SERVICE BULLETIN

Thunder-01

Thunder Bolt Roof Update

Bracket, Retro Roof Mechanism **Part#10830**

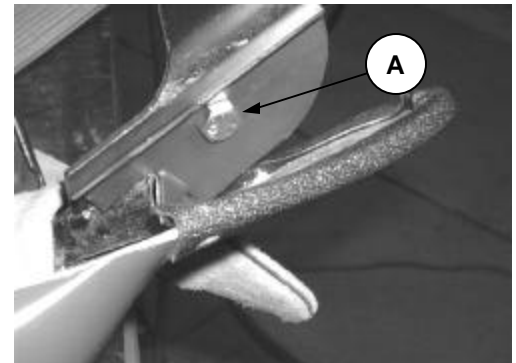
Excessive vibration causing roof hinge mount to crack.

Install retro bracket as describe in bulletin.
